C O R C O R A N
J E N N I S O N
Companies

Please see the attached Bayside DoubleTree Hotel expansion plan that was approved by the BRA and our plan with proposed changes. In summary these are the proposed changes:

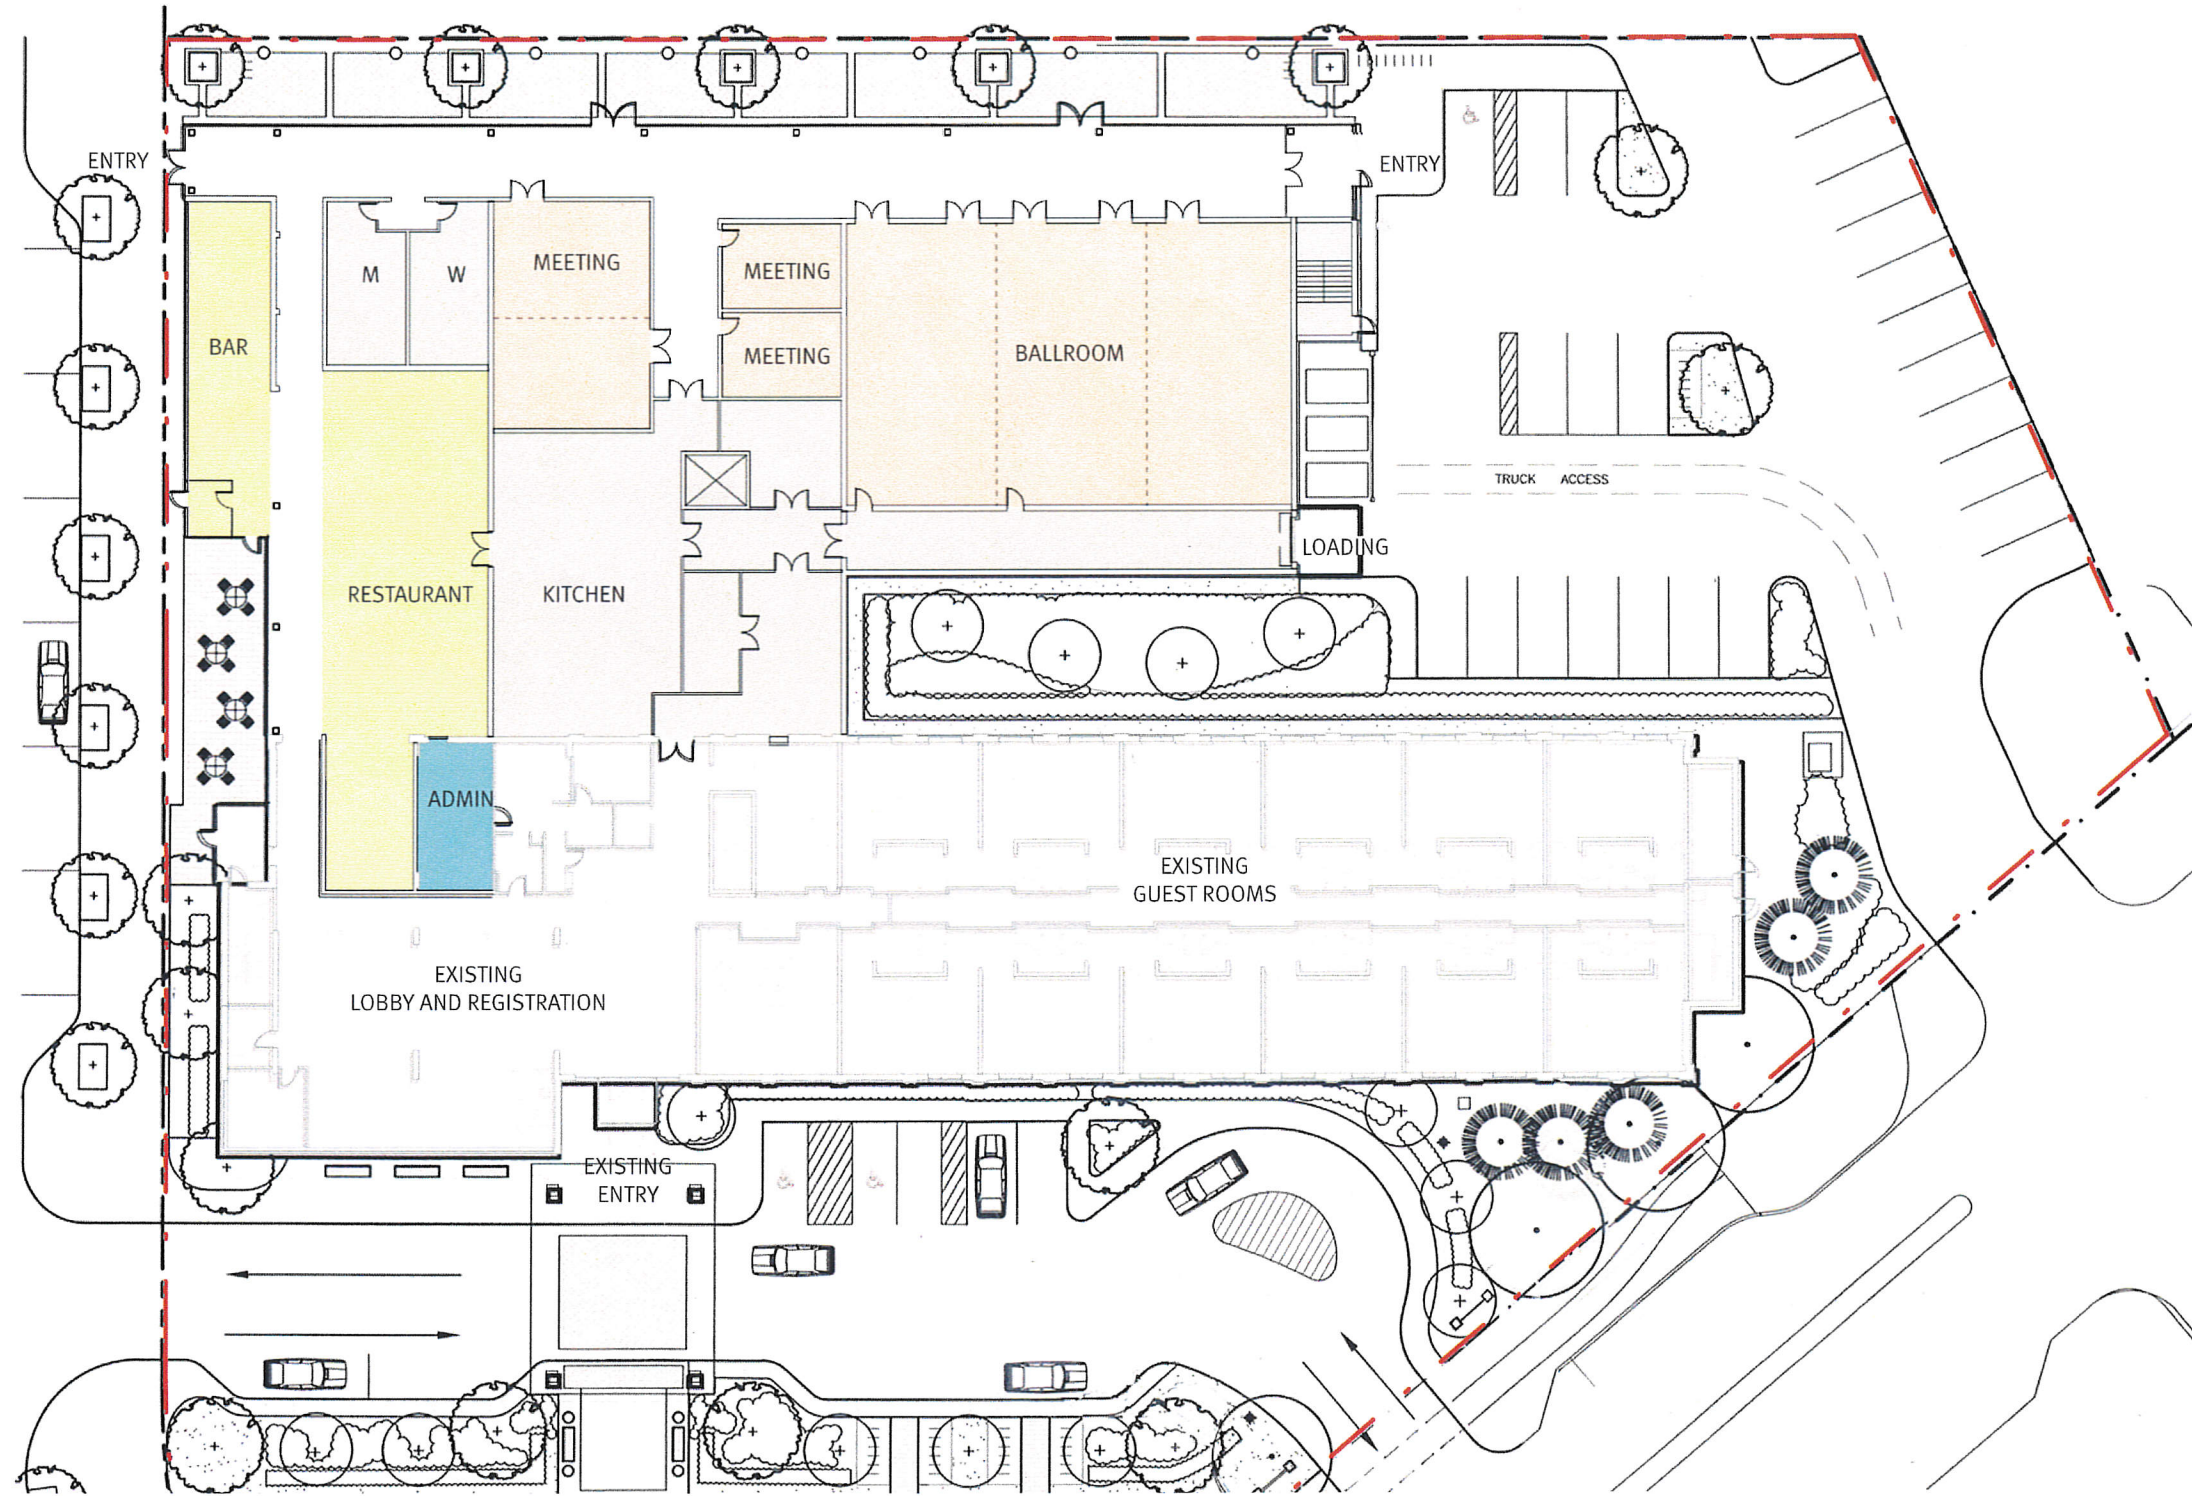
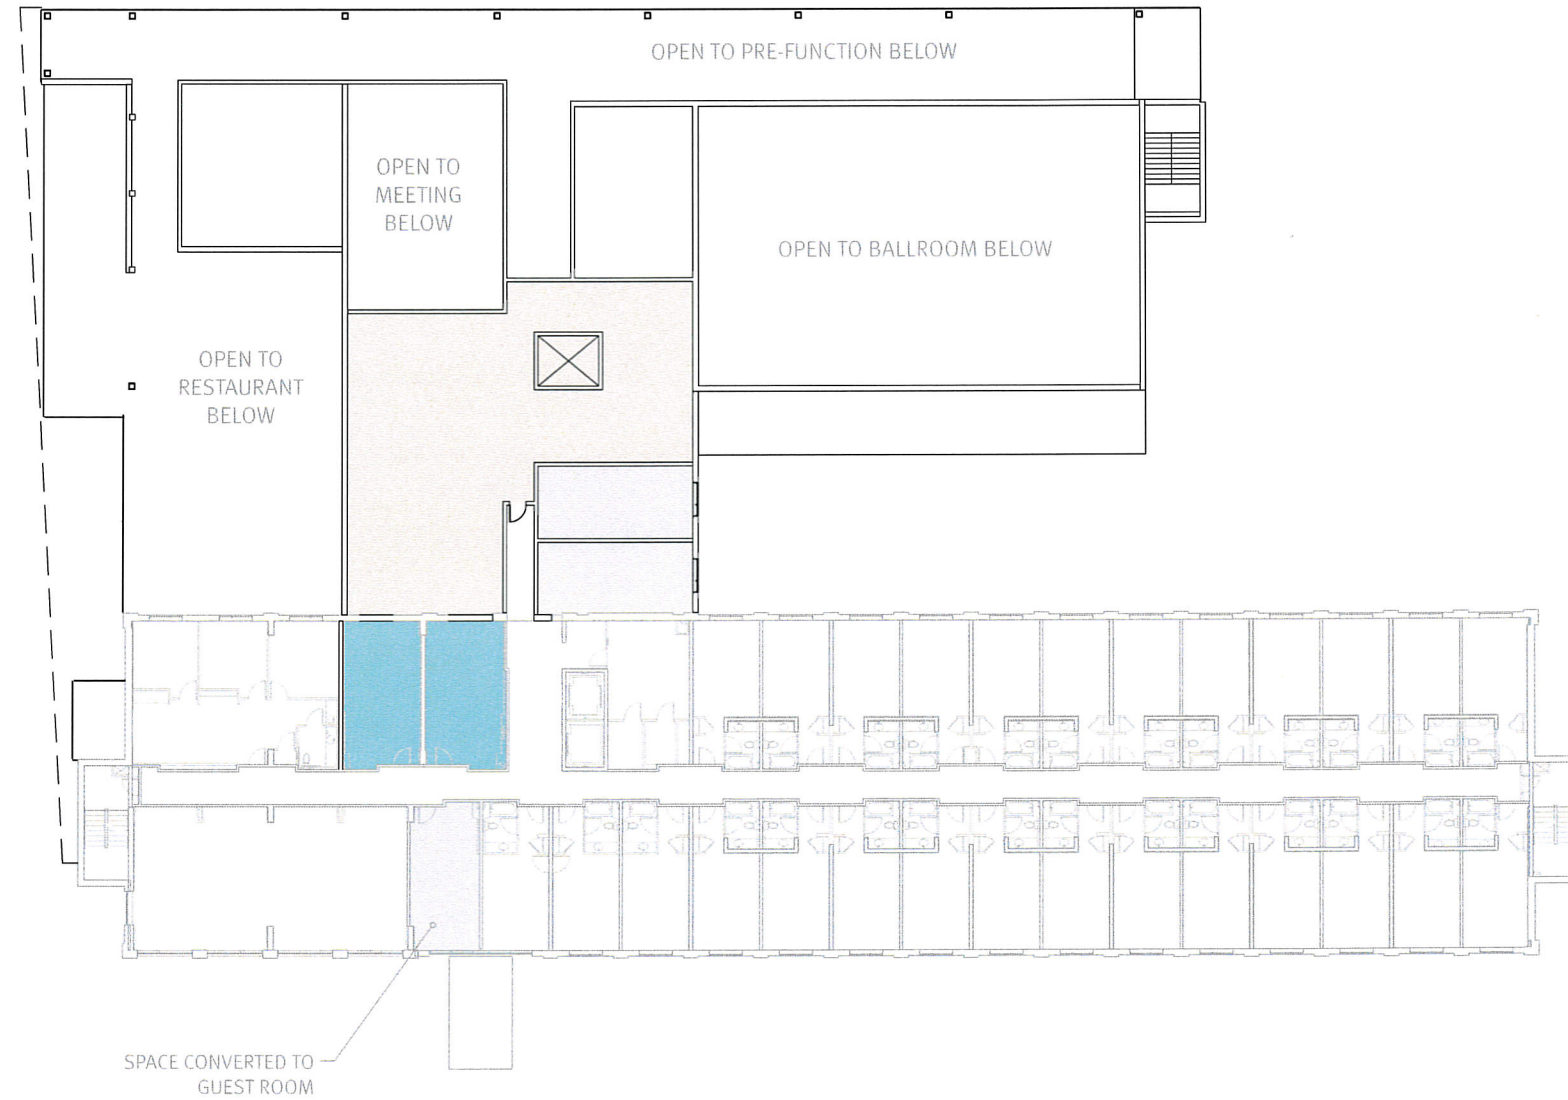
- The ballroom moved from the back right side of the addition to the back left side of the addition.
- The restaurant moved from the addition to the existing hotel lobby area.
- The footprint of the addition was reduced in size from the BRA approved 19,281 square feet to 17,259 square feet i.e. 2,022 square feet less.
- The BRA approved Gross Floor Area of 69,500 increased by 1,400 square feet to a Gross Floor Area of 70,900 GFA.
- The net increase in hotel guest rooms from the approved plan is 7 guest rooms, 97 guest room approved and 104 guest rooms proposed.
